PCO REVIEW FORM

Haverhill Consentino Middle School

PROPOSED CHANGE ORDER**No. CMS-008R1****TITLE:** ASI-06 Exhaust Fan Coordination**DATE:** 11/22/2024**PROJECT:** Dr. Albert B. Consentino Middle
School**JOB:** CSM-2024**TO:** City of Haverhill
685 Washington Street
Haverhill, MA**CONTRACT NO:****DESCRIPTION OF CHANGE**

SUBJECT: PCO #008R1: ASI-06 Exhaust Fan Coordination

PROJECT: Consentino Middle School
RFI NO.: 14P

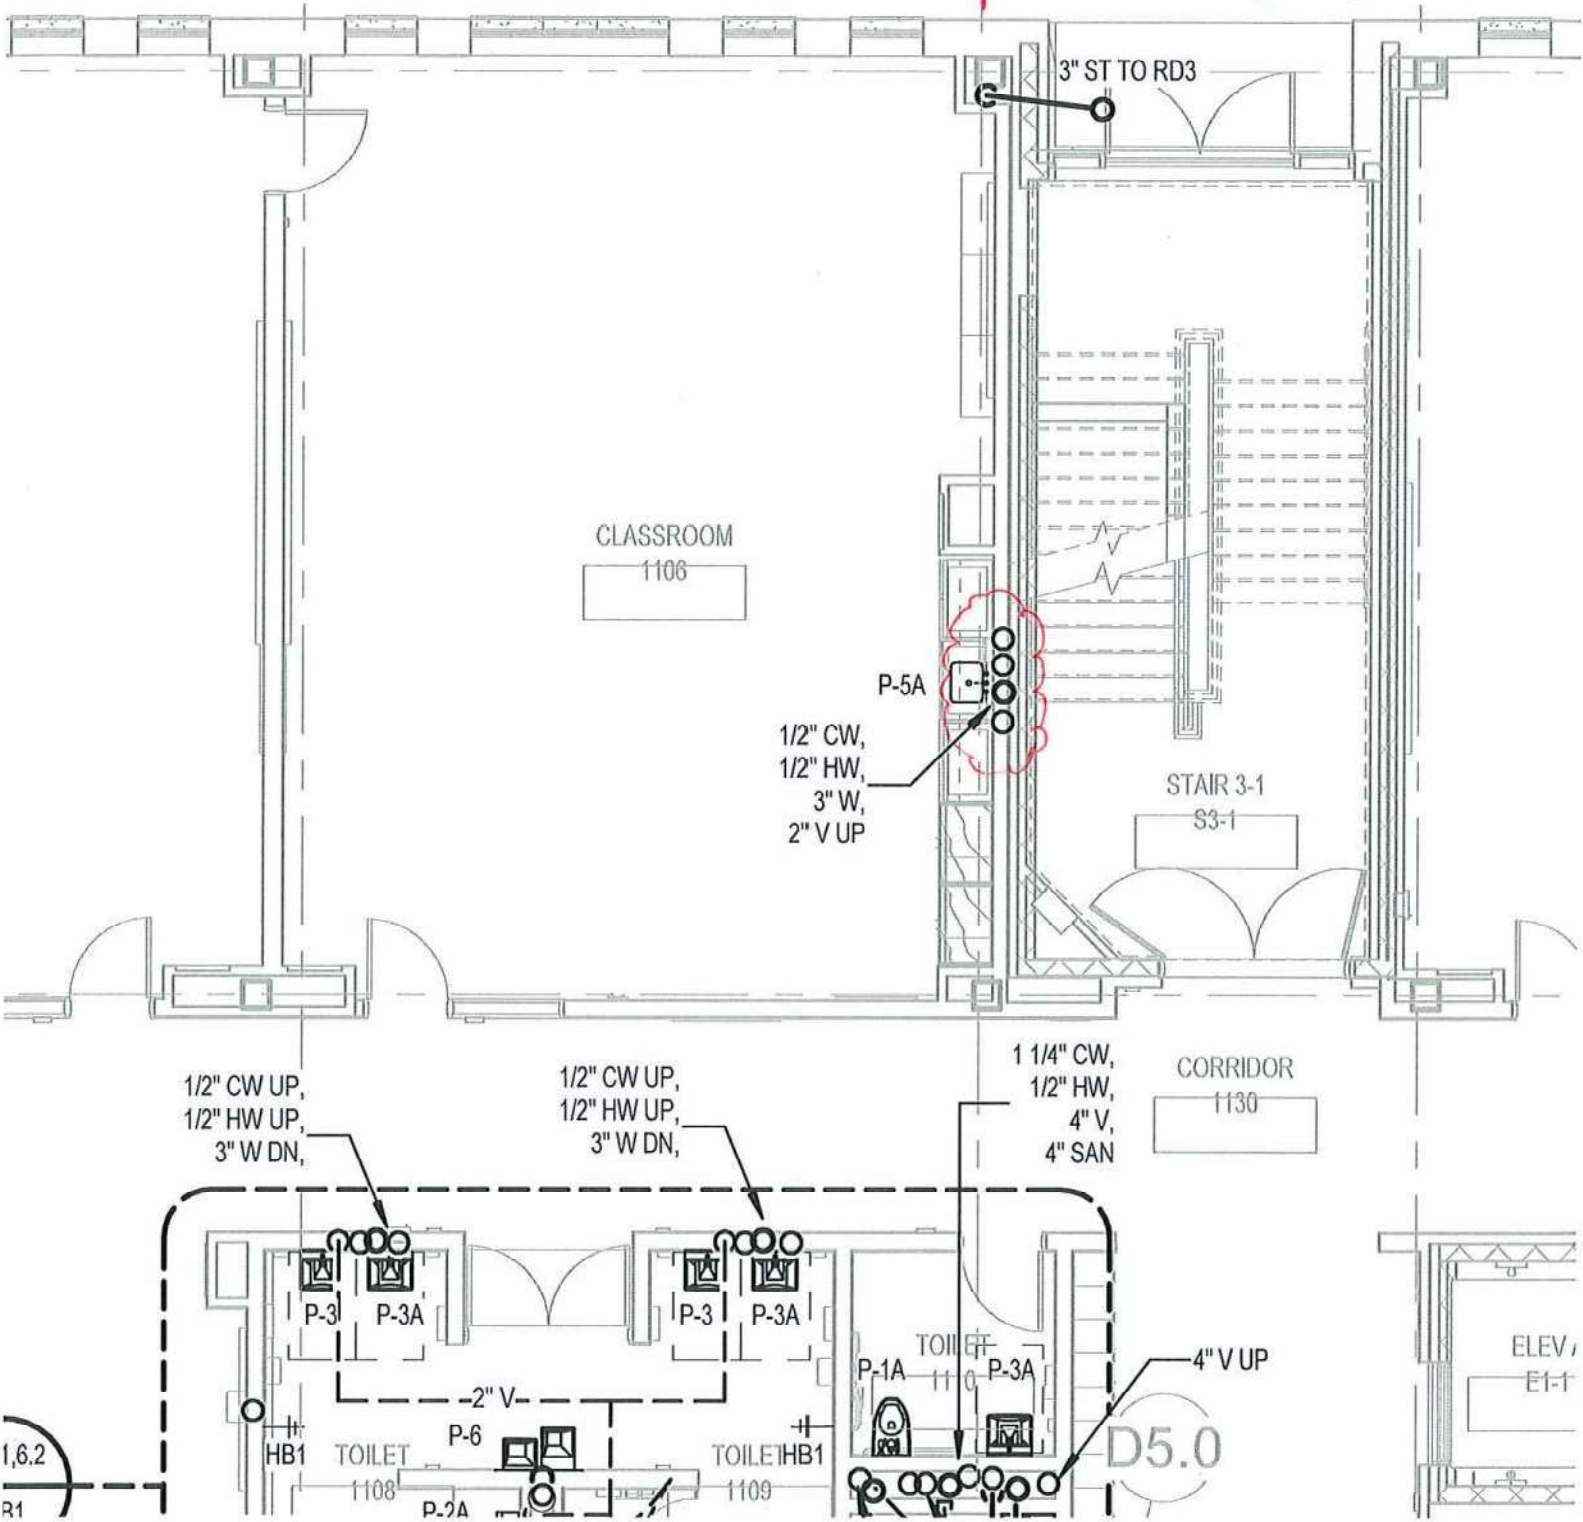
INFORMATION NEEDED: See attached snapshots. There is a conflict between steel beam, bend plate and sink piping on column line 3.0 in Building B. This occurs on all floors.

It is structurally acceptable to drill holes in the bent plate at the locations shown on the last page of this RFI.
